Reference: Utah National Guard Draper Headquarters- Office Remodel

Subject: Addendum No. 1

UTAH NATIONAL GUARD DRAPER HEADQUARTERS OFFICE REMODEL

ADDENDUM NO. 1

ASD-01

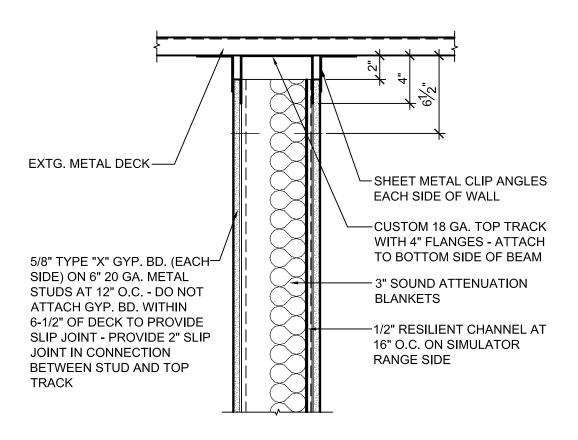
Provide a slip joint on the sound wall per detail ASD-01.
